NFPA 805 OBSERVATION VISIT TRIP REPORT¹

Date: August 6 - 9, 2007

Subject: Risk-Informed, Performance-Based Fire Protection Transition Pilot-Plant Observation Visit – Shearon Harris Nuclear Power Plant and Oconee Nuclear Station

Figure 1. Multiple Spurious Post-Transition Inspections

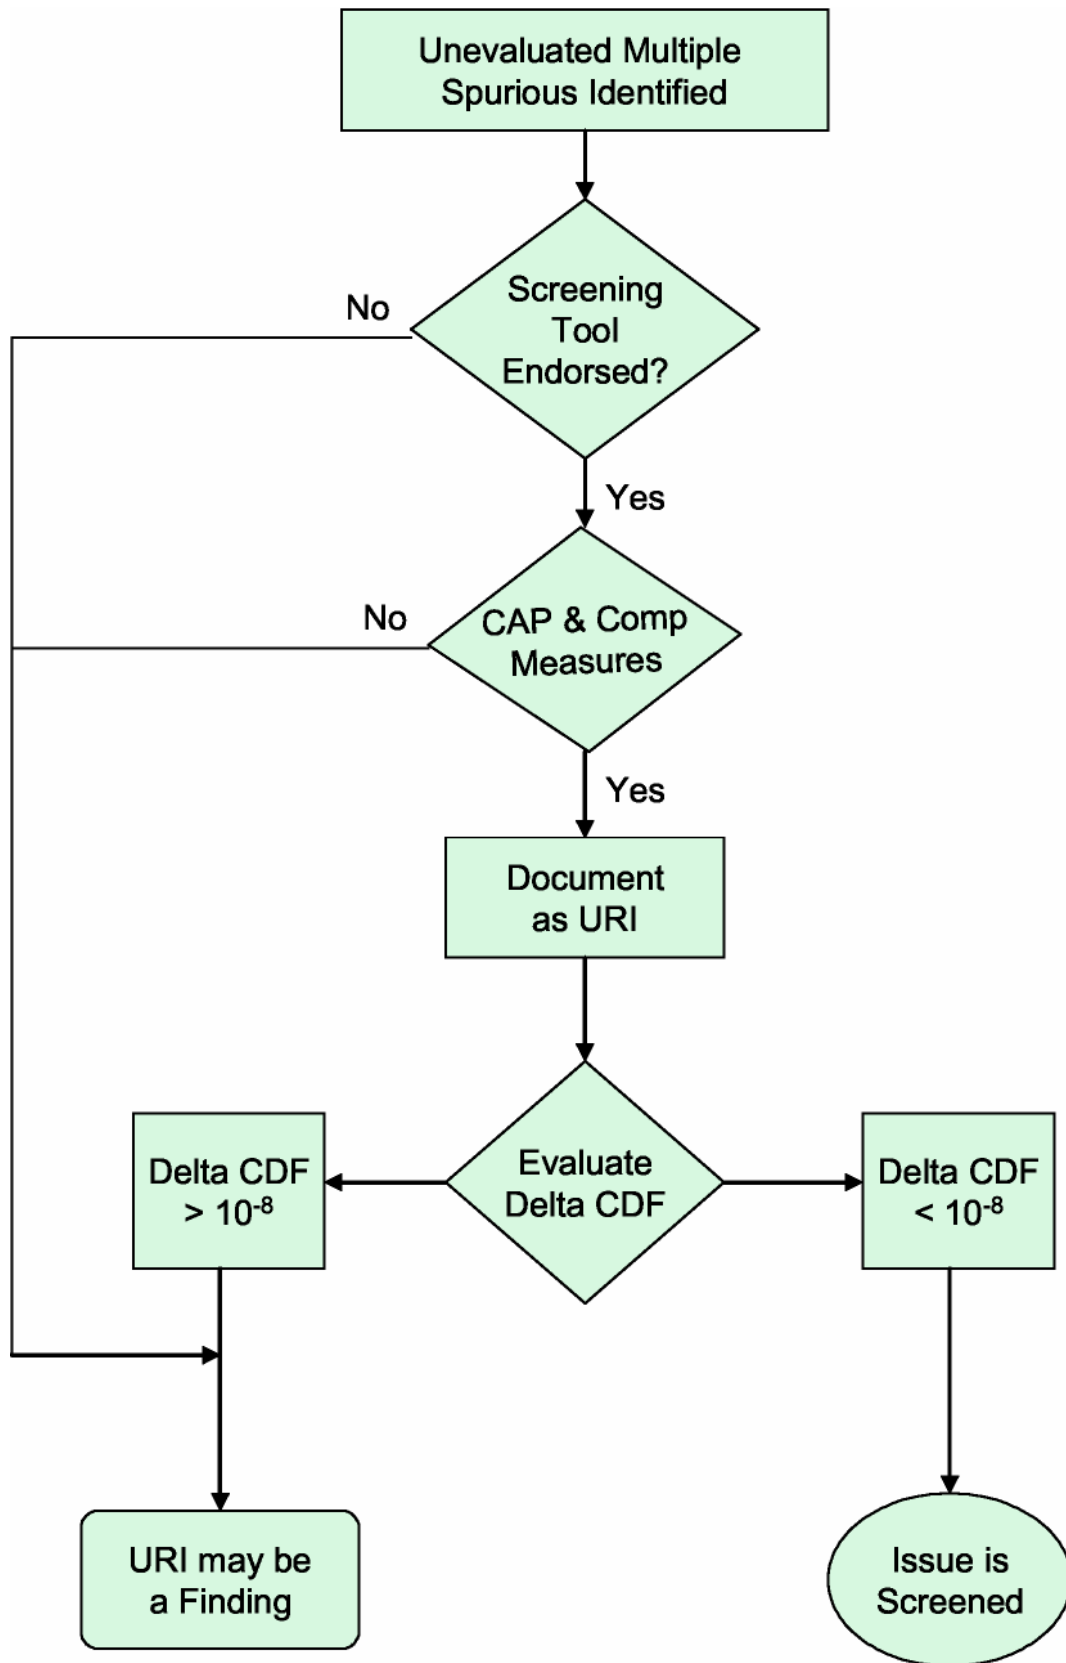
At the March 2006 pilot plant observation visit, the Staff presented a flow chart, illustrating how newly found multiple spurious circuits identified during an inspections, could be treated (See flow chart below). In addition to the flowchart, the following information was discussed:

Resolution Action(s)/Action Party: OPEN. Industry and pilot-plant participants agreed to review the flowchart, IMC 0612 questions, screening thresholds and provide feedback to the NRC at the next observation meeting. The industry may also submit an FAQ on the issue.
